DIAMANT

SERVICE

BULLETINS

**Flug- u. Fahrzeugwerke A. G.
Altenrhein**

Detail Y:

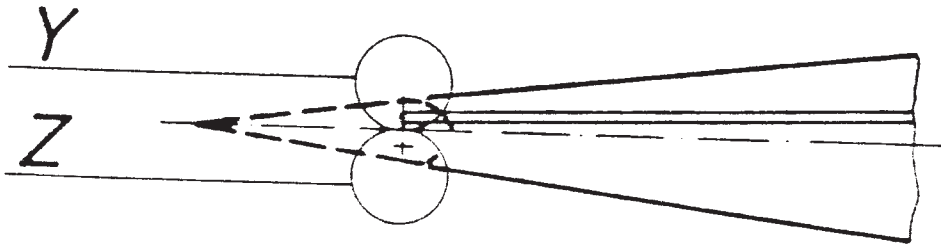
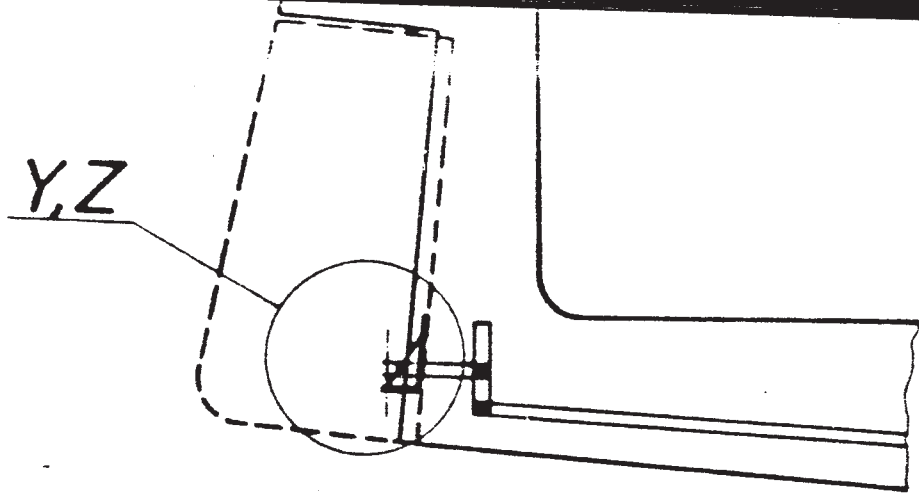
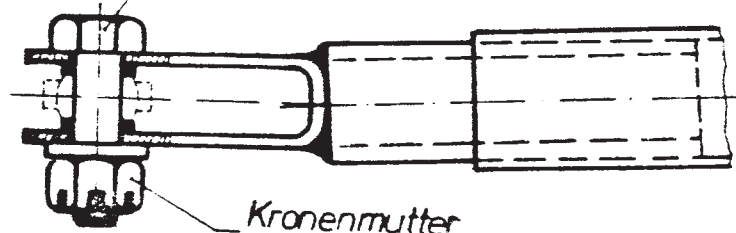
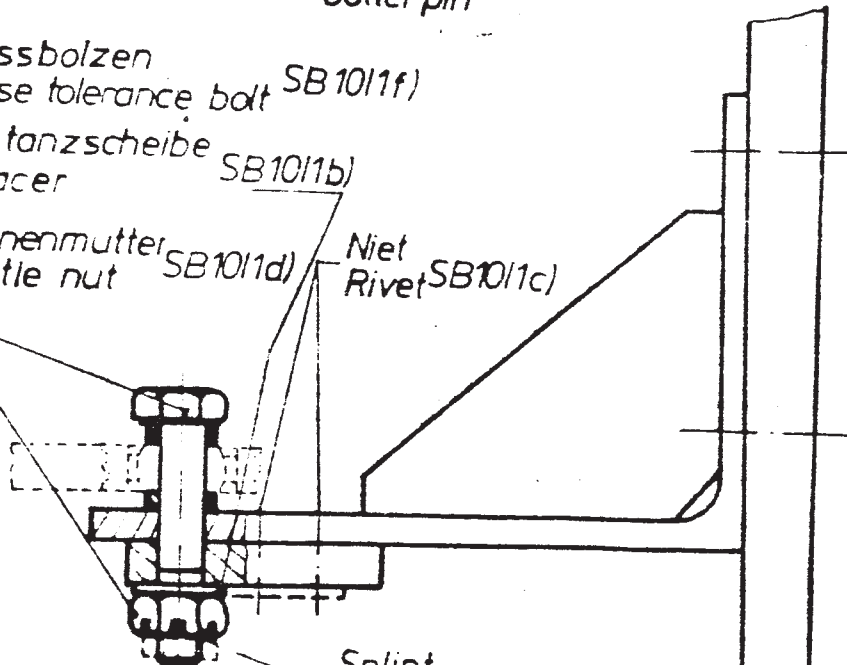
- Check tightness of close tolerance bolt
- Replacement of the close tolerance bolt, the connecting bolt and the self locking nut. Remove anchor nut according to working instructions (2.).

- 2.1.1. Push rudder to the right deflection limit so that the bolt is visible through the opening on the left side of the rudder.
- 2.1.2. Remove connecting bolt at the end of the push rod (bolt with nut, detail Y).
- 2.1.3. Remove close tolerance bolt (detail Z).
- 2.1.4. Remove rudder from the bearing block by pulling the rudder backwards. As soon as the rudder is off the bearing block, pull the rudder downwards to remove it from the upper bearing.

- 2.2.1. On the lower bearing block remove both rivets from the anchor nut. Then rivet bracket and sheet together again (without anchor nut).
- 2.2.2. Mount rudder in reverse order to item 2.1. (with parts on sketch SB10 /1).
- 2.2.3. Check deflections according to the Flight Manual. Item 5.2 ($+30^{\circ}$, $+3^{\circ}$, -0°)
- 2.2.4. Check rudder and elevator controls for free movement

3. <u>Material:</u>	1 Connecting bolt	D1.206-0303.1	SB 10/1 a)
	1 Spacer	AN 960-C10L	SB 10/1 b)
	2 Castle nuts	M6 VSM 13780	SB 10/1 d)
	2 Cotter pins	1,6 x 16 VSM 12760	SB 10/1 e)
	1 Close tolerance bolt	D1.201-1228.1	SB 10/1 f)
	2 Rivets	MS 20470-AD2-10	SB 10/1 c)
